Proposed Cell Tower Placement Near Matson Airport

July 10, 2023

Aviation Safety Compliance, LLC

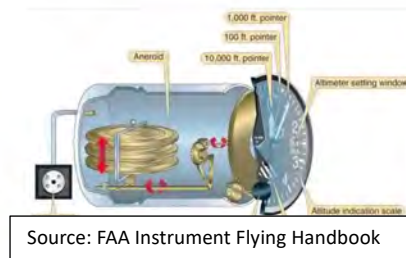
When landing at the Matson to the South, the proposed tower would have aircraft overflying it at less than 300 feet above the ground. According to topographical maps it appears the proposed site is approximately 30 feet below the runway resulting in a 30-foot increase in clearance for aircraft. Aircraft flying over at 300 feet would have 131-foot clearance.

At 5088 feet from the departure (arrival to runway 18), end the aircraft will be descending. Considering the 30-foot decrease in elevation aircraft will pass over the proposed tower around 100 feet, using the calculation $(267+30-199=98)$. One additional consideration is the accuracy of the altimeter on the aircraft.

Altimeter error could erode the 100-foot clearance margin by as much as 75 feet, leaving only a 25-foot clearance (considering the tower is at 199').

1. Move the proposed tower site East or West of the current site to deconflict with air traffic using Matson Airport.
2. If the tower is erected on the proposed site, it should be lighted day (white) and night (red).
3. If the tower is erected in the proposed site, it should be of a height not to exceed 163 feet above ground level.
